**Re: Enbridge Gas Inc. (Enbridge Gas)  
Ontario Energy Board (OEB) File No. EB-2022-0086  
Dawn to Corunna Replacement Project  
Interrogatory Responses - Redacted**

Answer to Interrogatory from  
OEB Staff ("STAFF")

Figure 1

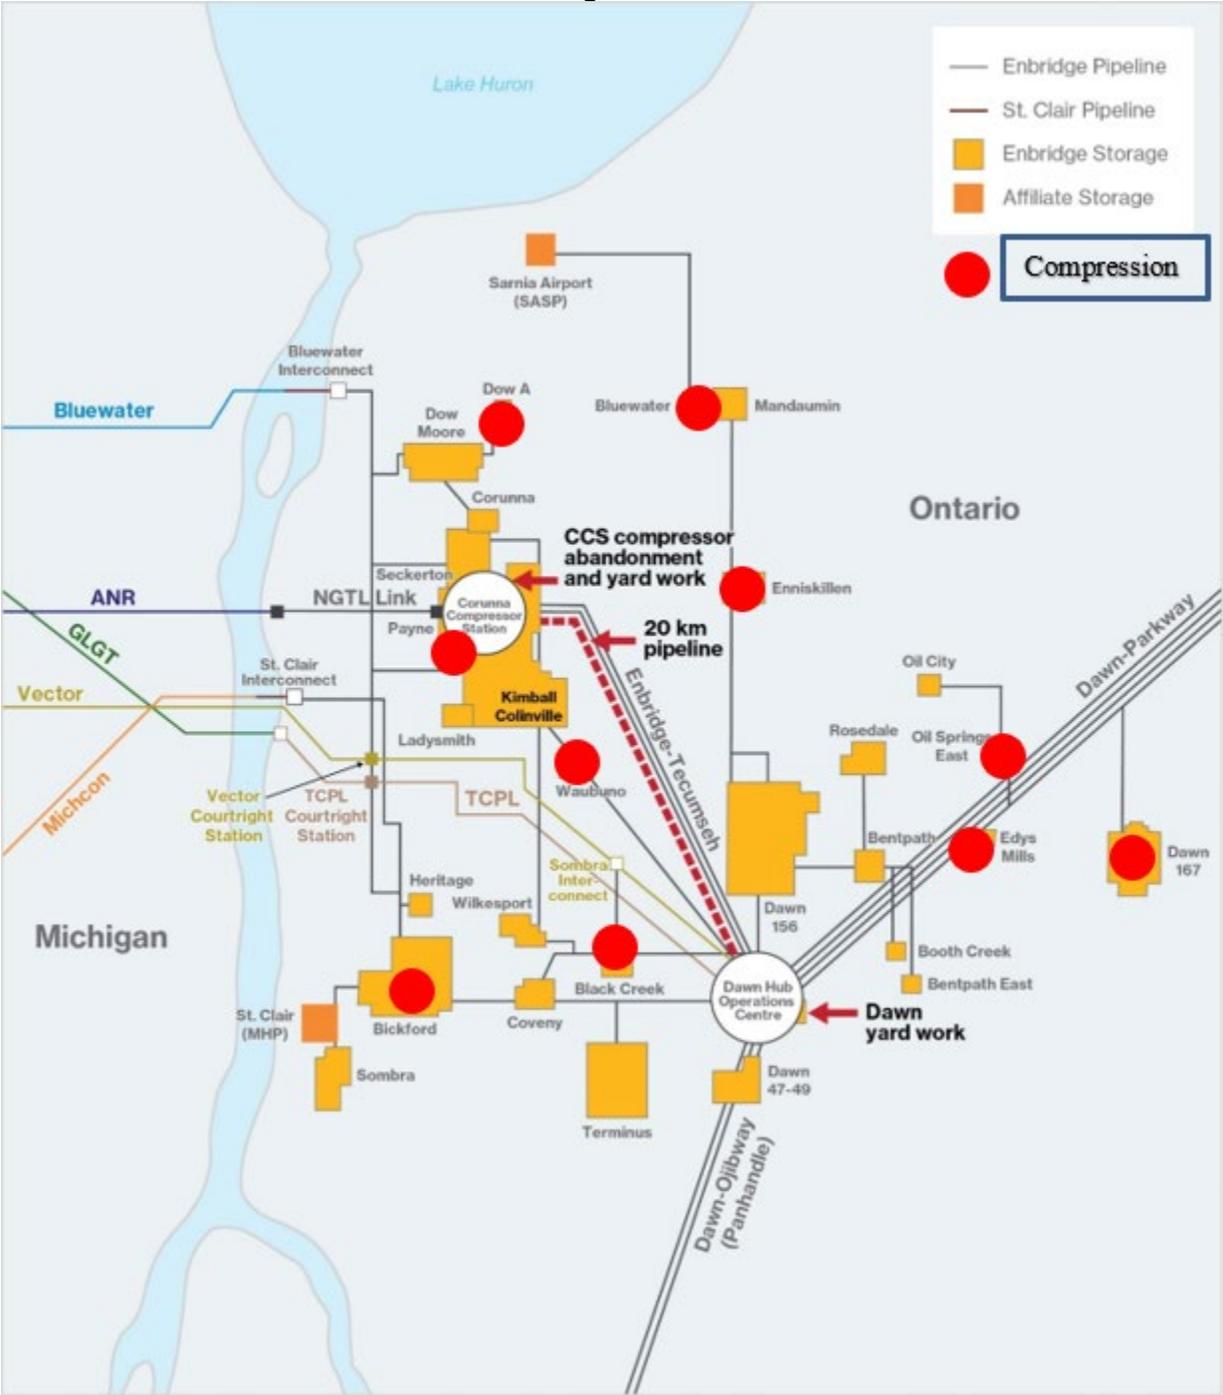
- a) Does Figure 1 show all compressor stations in the storage system or only Corunna?
- b) Please provide a version of Figure 1 (or equivalent map) showing all compressor stations in the storage system.
- c) For each compressor station referred to in part b (above), please provide short description of the purpose and how it relates to Corunna.

- a) Figure 1 shows the CCS and the Dawn Operations Centre. These are the primary compressor stations in the Enbridge Gas storage system.
- b) In addition to the primary compression highlighted in Figure 1, the included map highlights the remaining compression locations in the storage system except for Chatham D, Tipperary, Crowland and Hagar. Chatham D, Tipperary, Crowland and Hagar compressors are remote facilities located outside the mapped area dedicated to the local operation of their corresponding storage pools/facilities.
- c) Table 1 summarizes the purpose of each compressor in the storage system. Figure 1 sets out the location of each compressor described in Table 1 (excluding remote facilities).
